# FLYING HORSE NORTH FILING NO. 3 INITIAL/ INTERIM/ FINAL GRADING & EROSION CONTROL PLAN

EPC STORMWATER REVIEW COMMENTS  
IN ORANGE BOXES WITH BLACK TEXT

GRADING & EROSION CONTROL PLAN  
 COVER

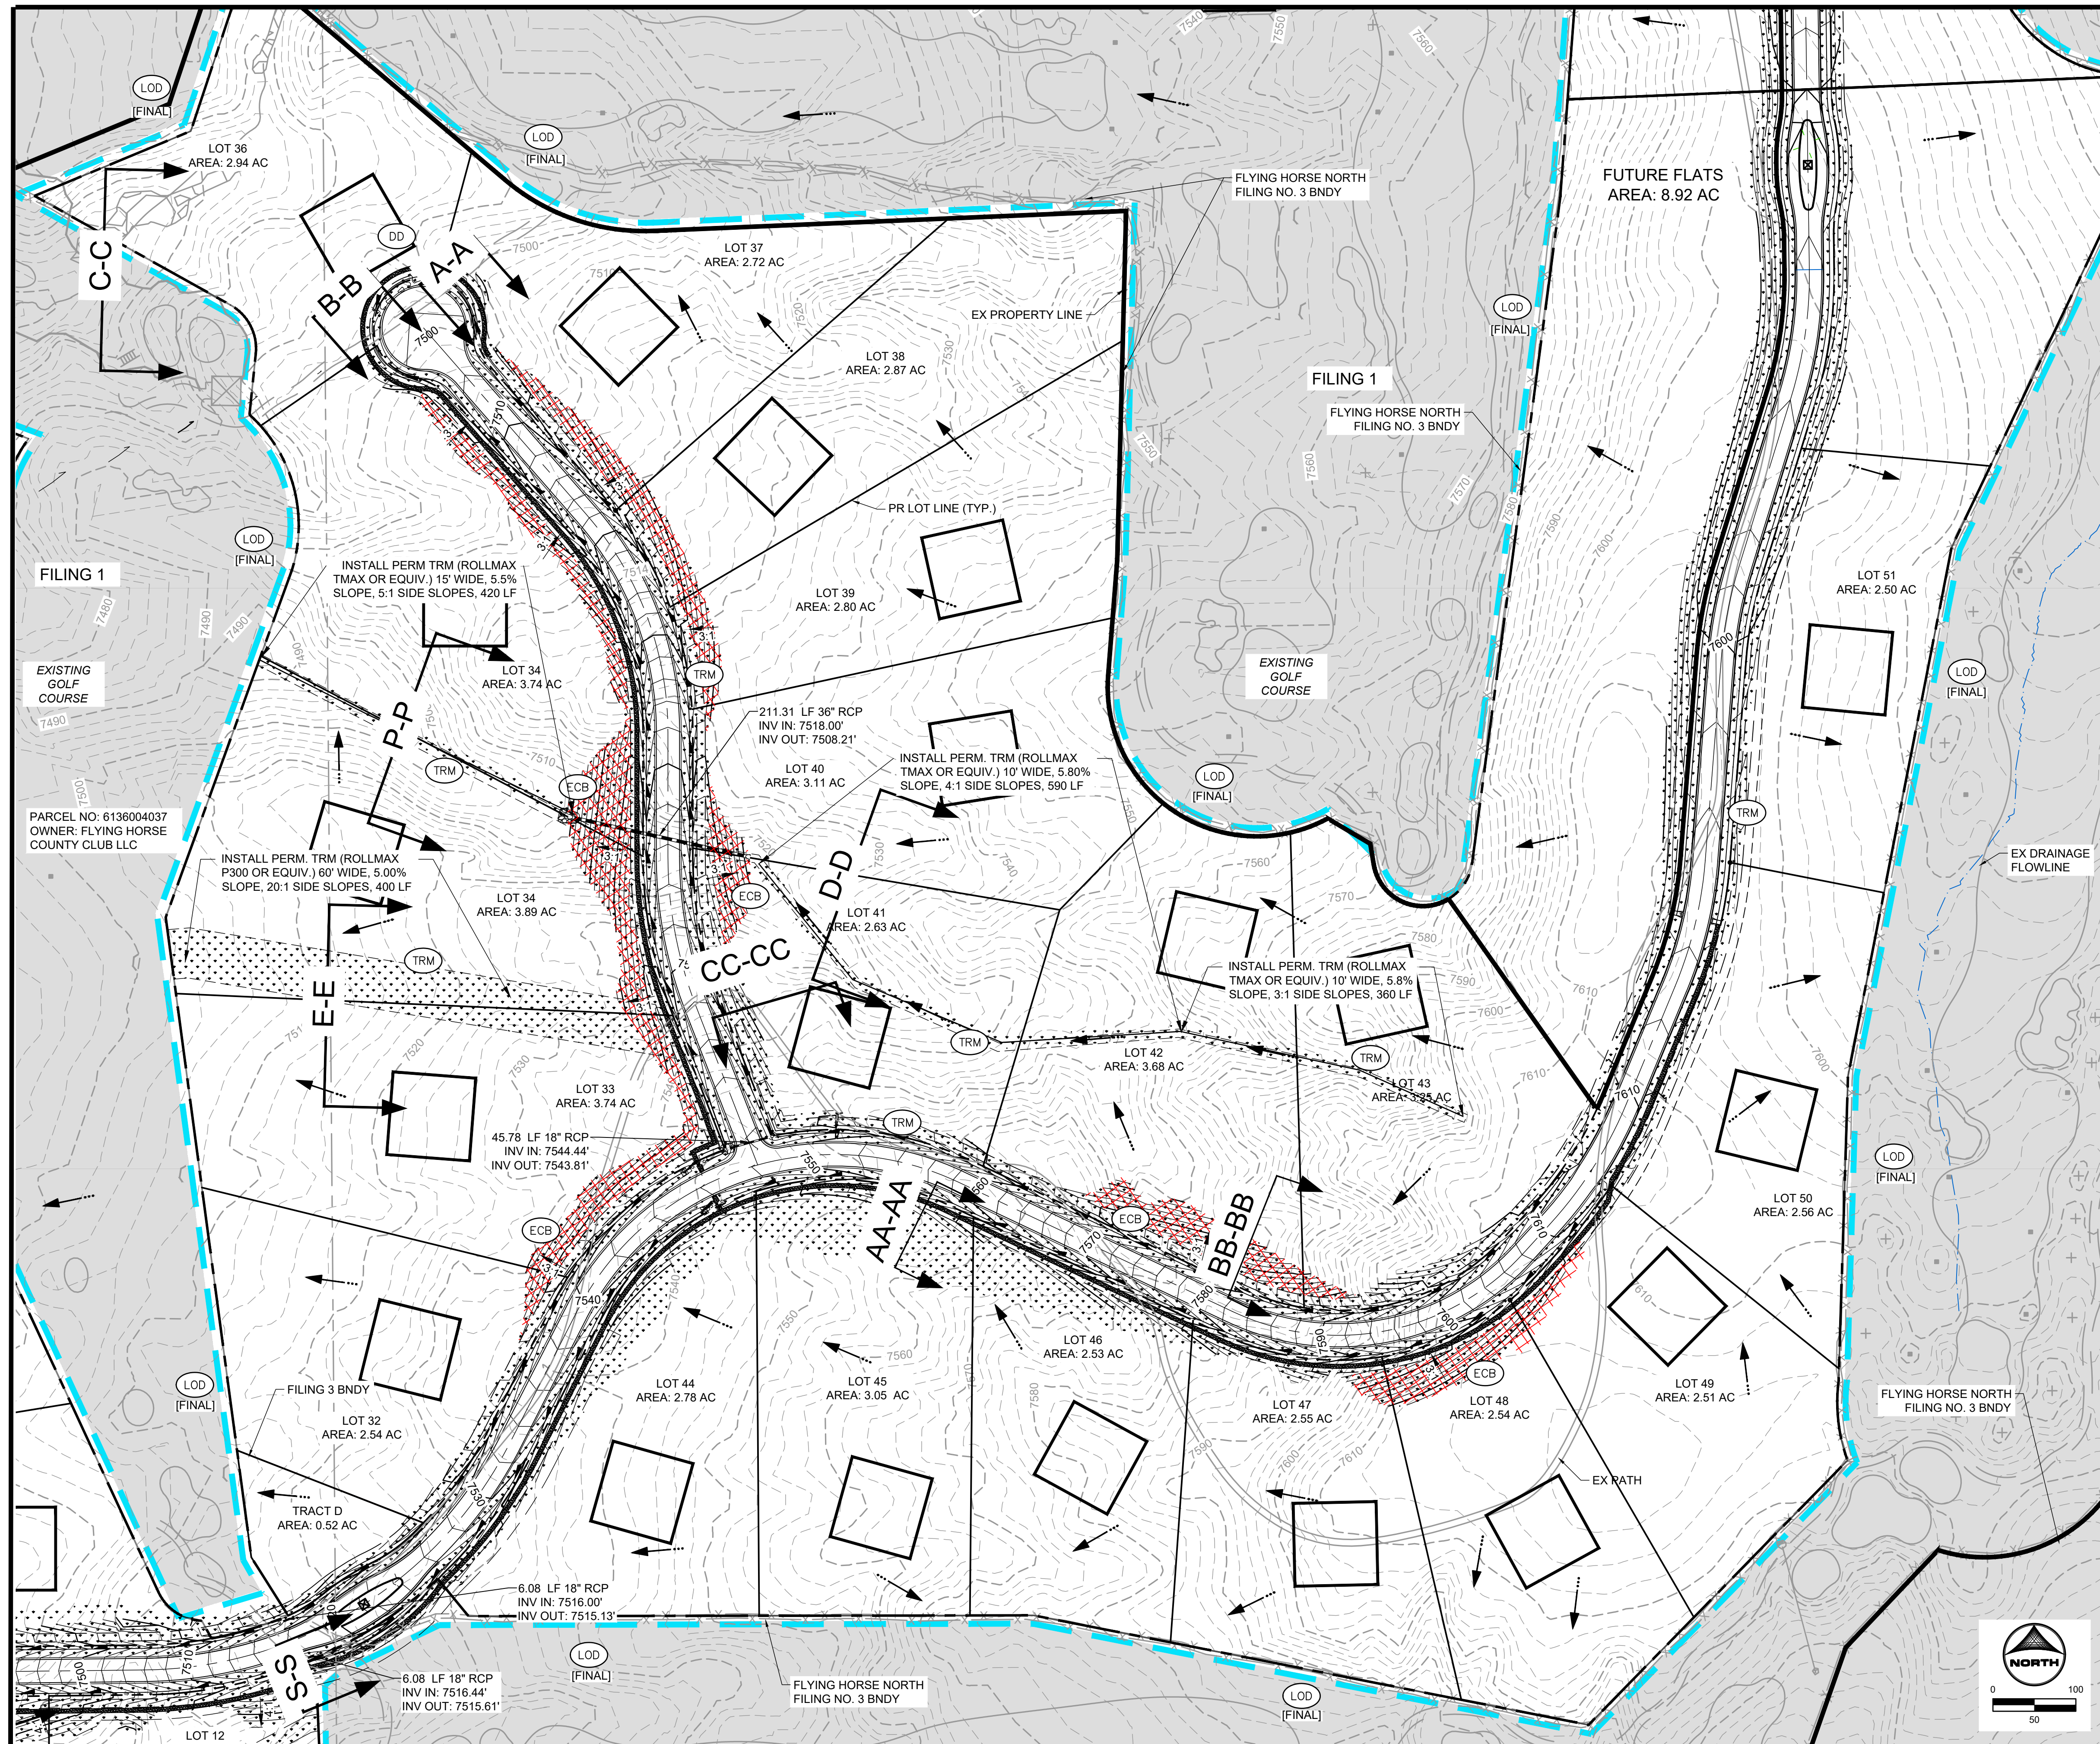
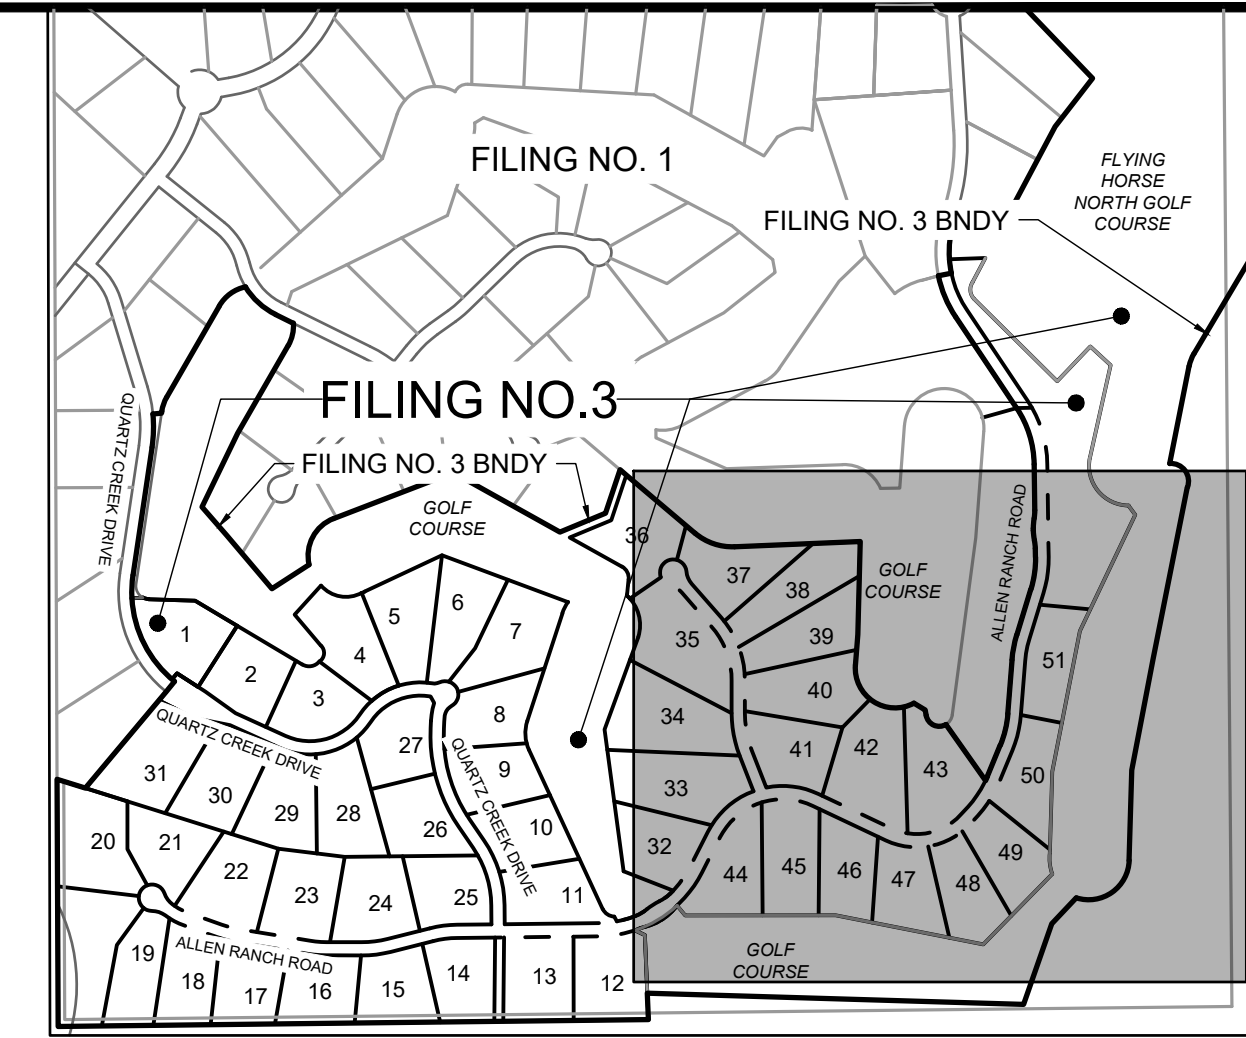
The CD's indicate a 3:1 slope, revise accordingly

**FAE REVISED ACCORDINGLY**
